Dr. JORAM HOPENFELD

Demonstration of Flawed Presentation of CHECWORKS Data

Figure 2a:

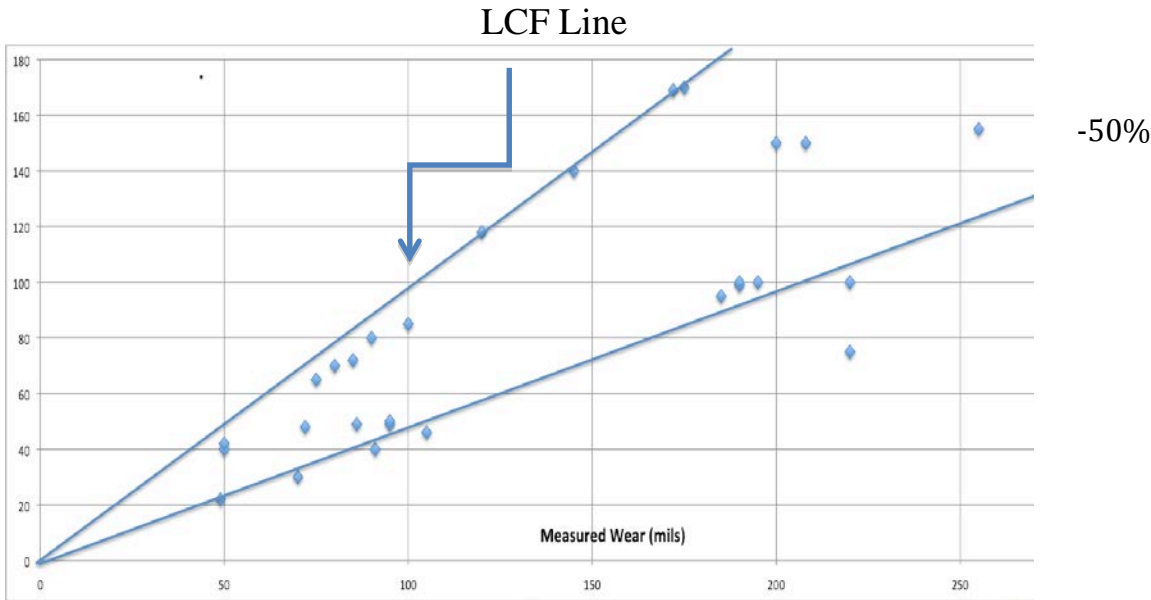
The non-conservative area of Figure 1 is re-plotted for comparison with Figure 3b below. Predicted wear on the y axis, measured wear on the X-axis. Top line is the LCF=1.060 line:

Showing how many more non-conservative points are not bounded by the 50% when the measured data is plotted on the Y axis and the predicted data on the x axis:
